BUNGALOW
Remove Hedges:
H98
H99
H100
H101
H102
H103
H104
497
535
Not allowed due to Service Strip.
All trees move back 0.7m from kerb.
Pumping Station
Mollon qa
Mollon opp
Hatfield opp
Hatfield qa
Ianbury opp
Ianbury qa
Rufford opp
Rufford qa
Rosebery qa
Rosebery opp
SWALE
7
8
9
13
14
15
16
17
18
19
20
21
22
23
24
25
DETAILED PLANNING PROPOSALS

remove H60 & S20 locally.
0.5m behind all VP's is to be hardstanding.
New layout
MP 5
DETAILED PLANNING PROPOSALS

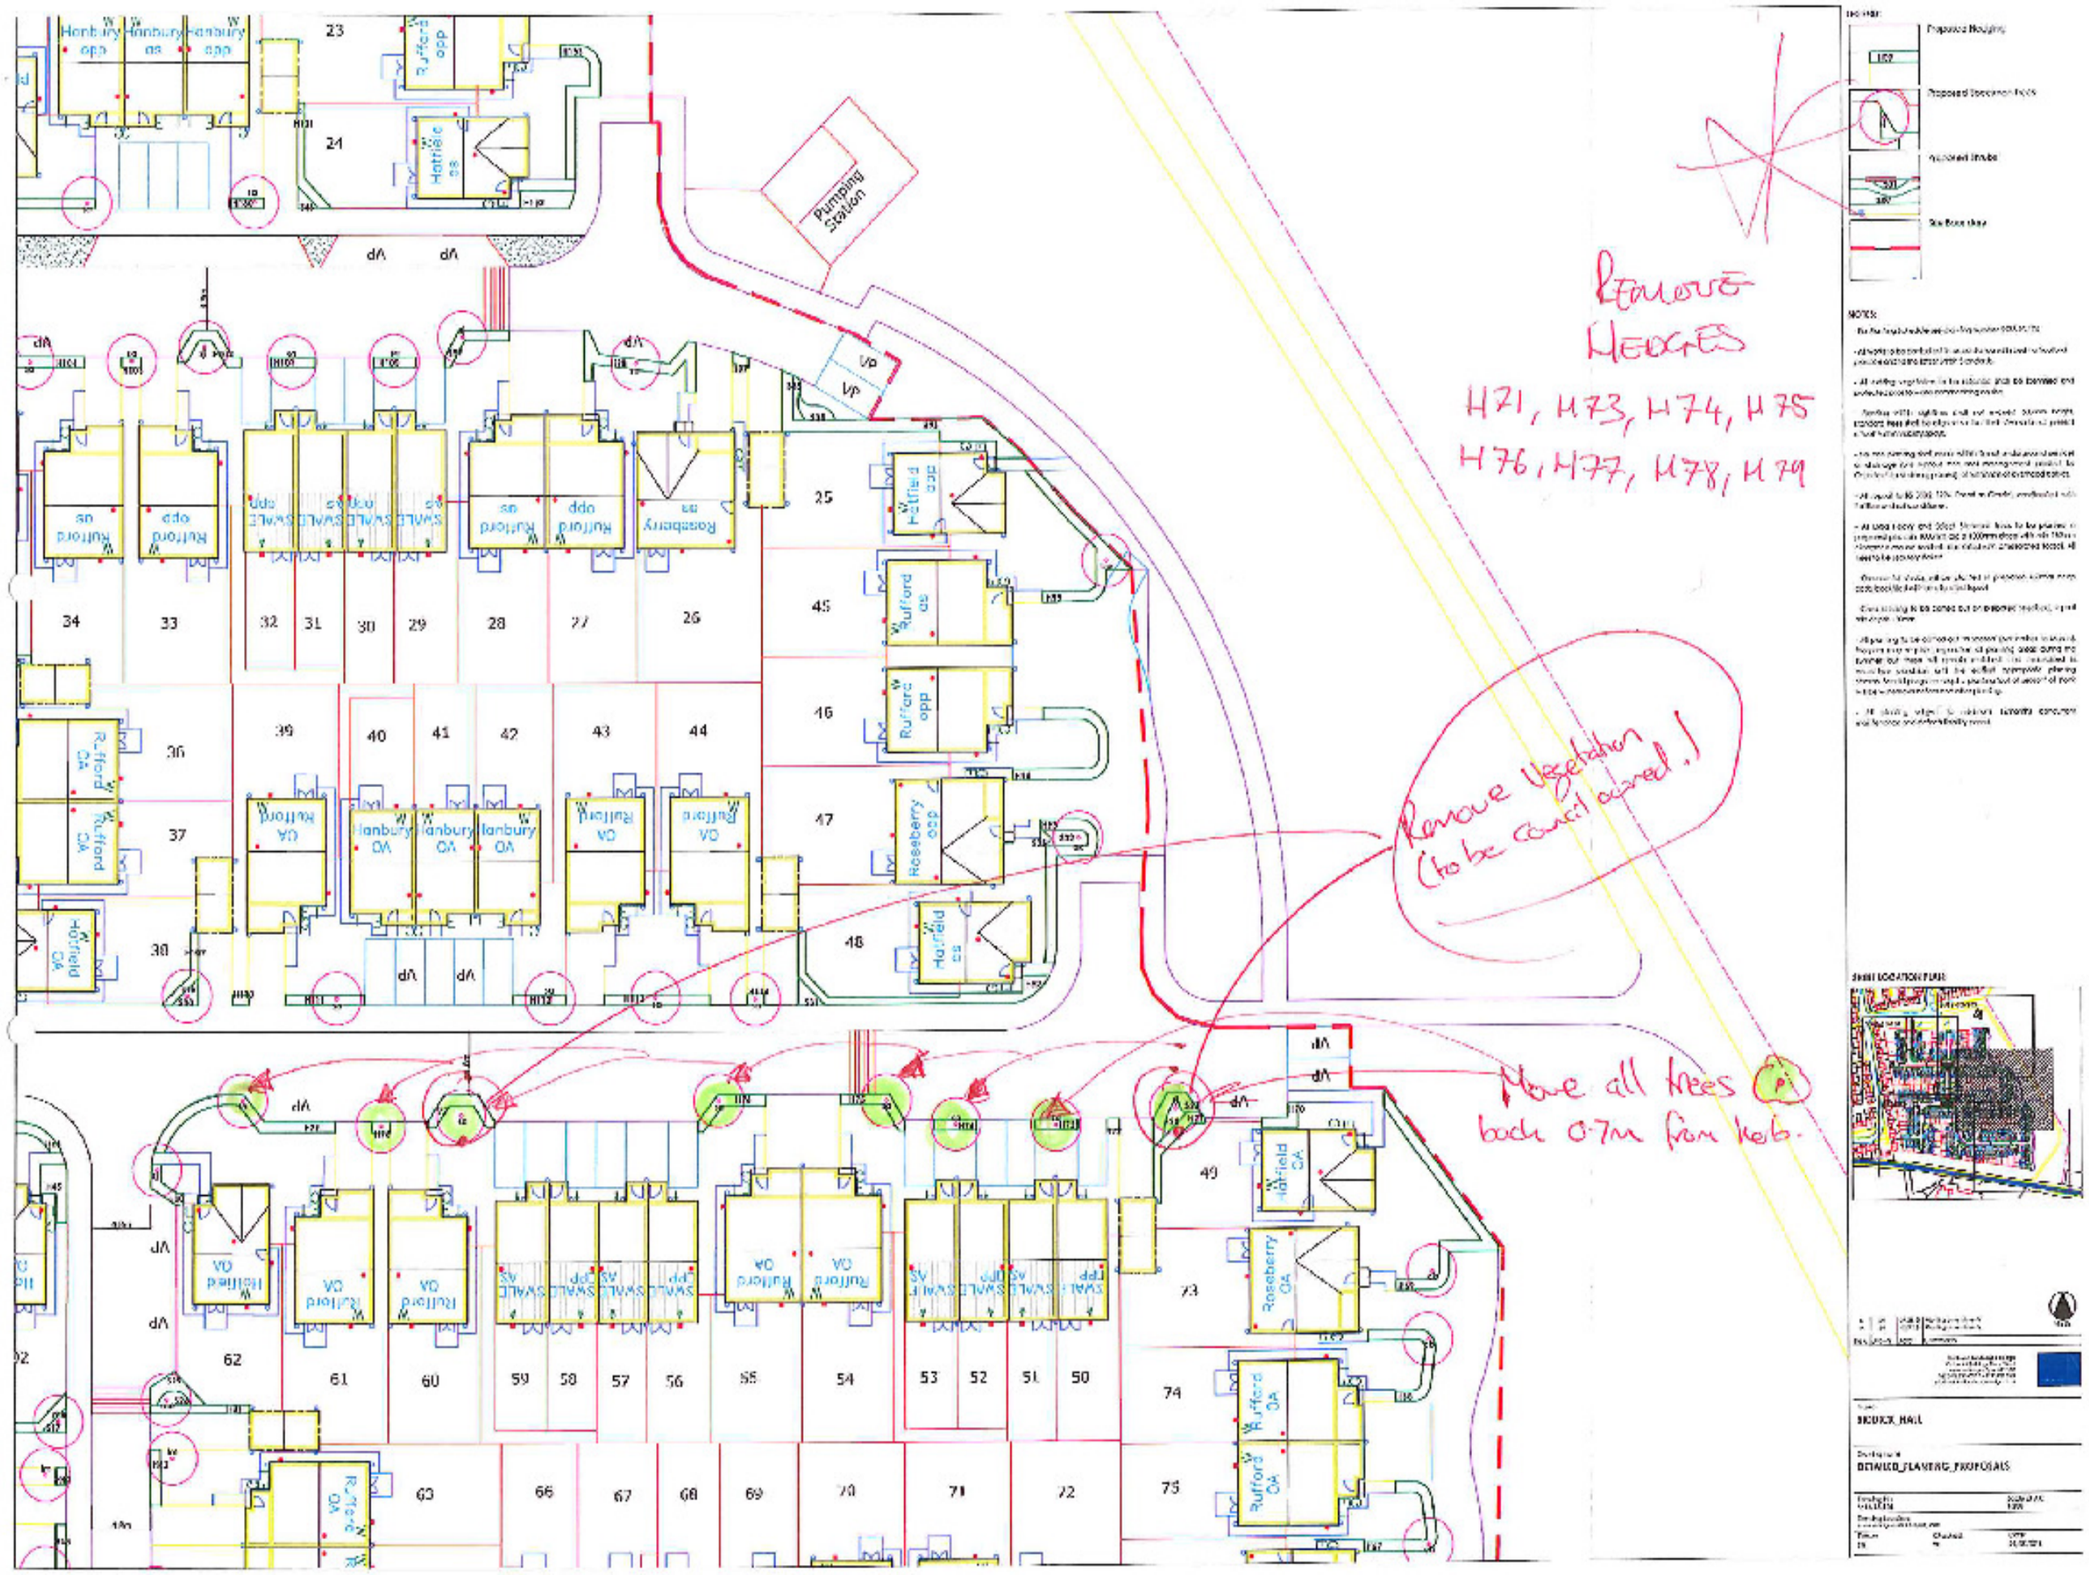
Tree
Move minimum
0.7m from kerb

Proposed Hedging
Proposed Specimen Tree
Proposed Tree
Site Boundary
NOTES:
Move min 0.7m from kerb
remove H23 (headstanding)
remove tree
remove hedging (light column)
0.7m from kerb
Move trees minimum 0.7m from kerb
remove H23 (will be headstanding)
Rutford
Hartland
Roseberry
Harbury
Hatfield
Moulton
Swale
Swale Apt
Swale Apt Upp
Swale Tree Pit
Swale Tree Pit Upp
Swale Apt Upp
Swale Apt

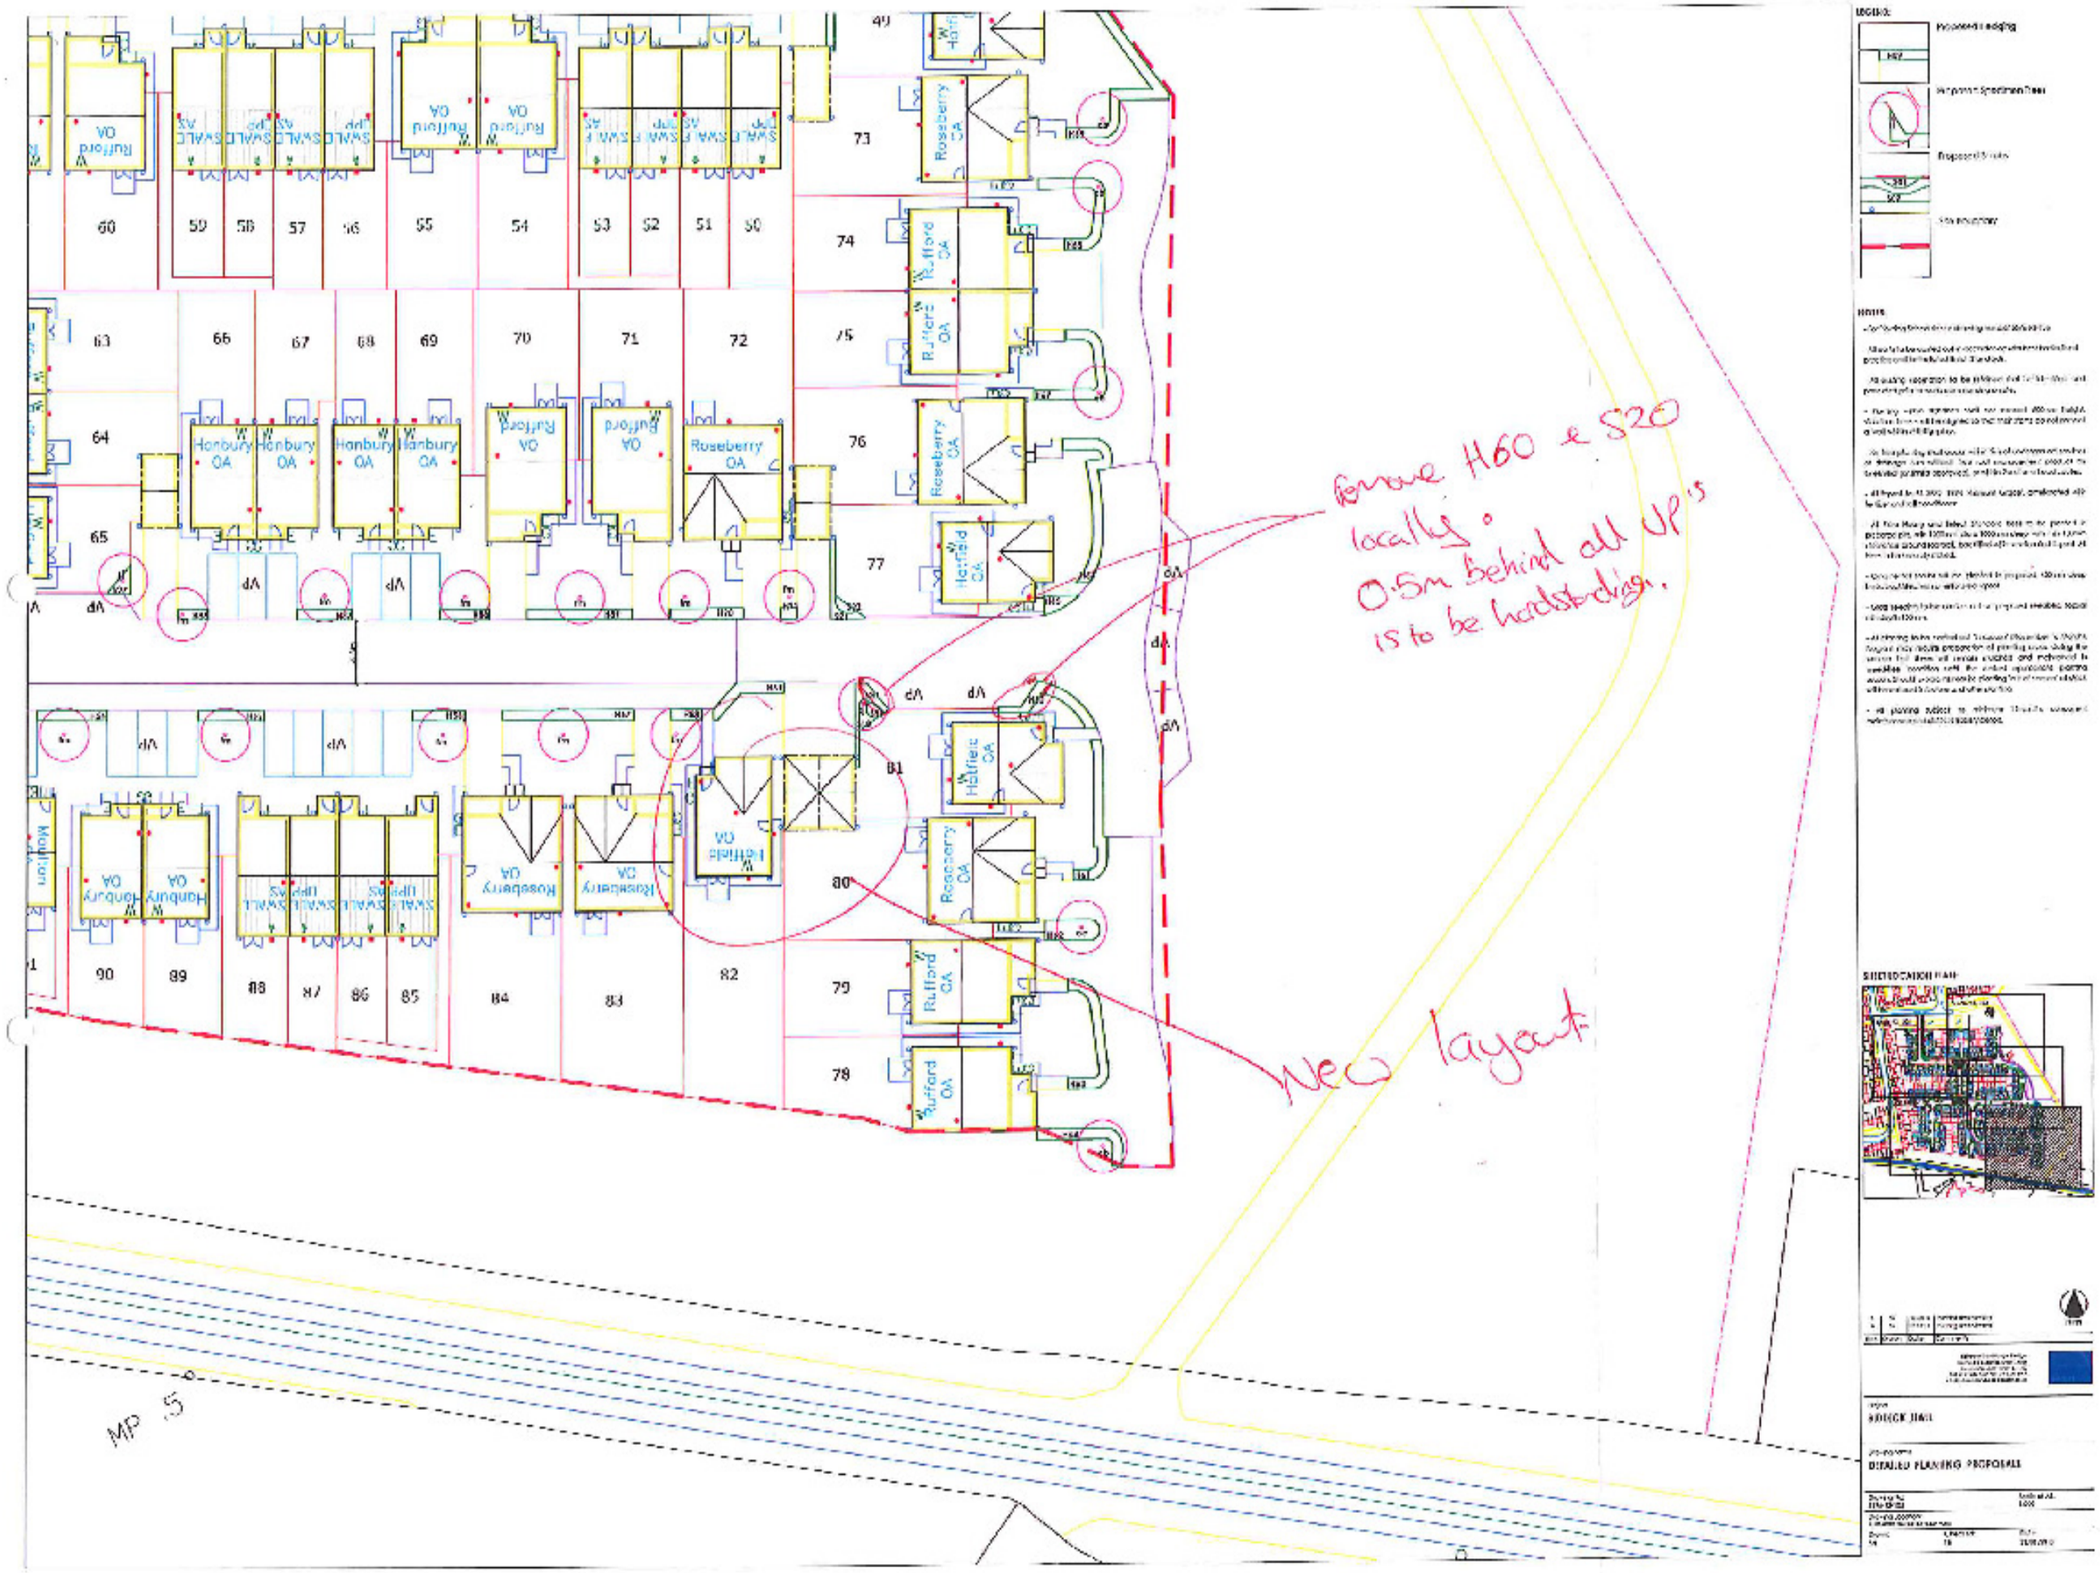
Pumping Station
REMOVE HEDGES
H71, H73, H74, H75
H76, H77, H78, H79
Remove Vegetation (to be council owned.)
Move all trees back 0.7m from kerb.
